## **PROPOSED NORTH ELEVATION**

## CHIMNEY B REPLACED WITH ONE TO MATCH A CEDRAL RIVENDALE SLATES SLATES AS EXISTING JUBILEE GROVE FIELD PAINTED RENDER-AS EXISTING \*\*\*\*\*\* RL 15.000 15.000 **Dec**cos NEW PAINTED METAL GATE TO MATCH STYLE OF EXISTING FENCE **PROPOSED EAST ELEVATION**

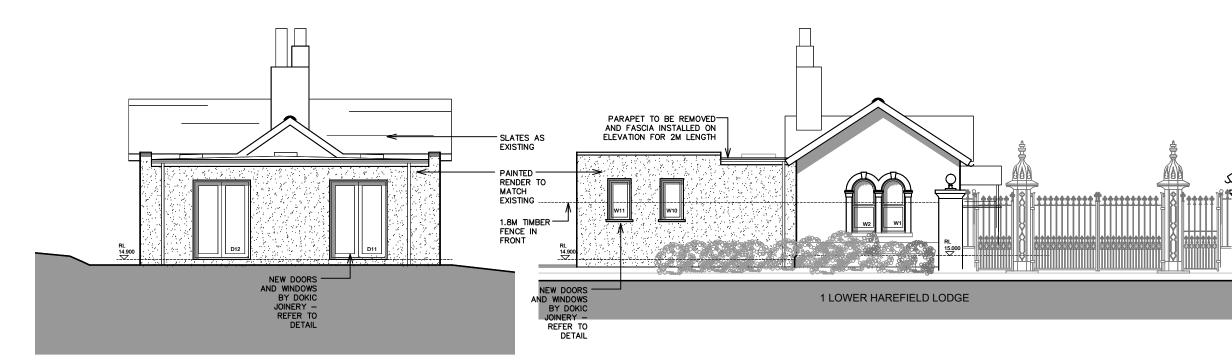
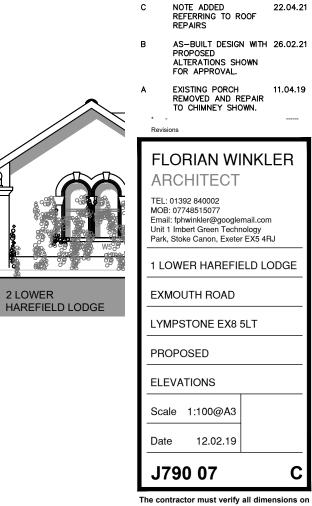
DURING THE WORKS MANY OF THE TIMBERS IN THE ORIGINAL HOUSE HAVE BEEN FOUND TO BE ROTTEN. THESE TIMBERS ARE TO BE REPLACED WITH MATCHING TIMBERS AS REQUIRED. EXISTING SLATES ARE TO BE REPLACED WITH CORDAL PLYENDALE SLATES

- THIS CHIMNEY POT IS TO BE EITHER REPLACED WITH ORIGINAL ONE FOUND ON SITE IF IT CAN BE REPARED OR

NEW/RECLAIMED TO MATCH EXISTING
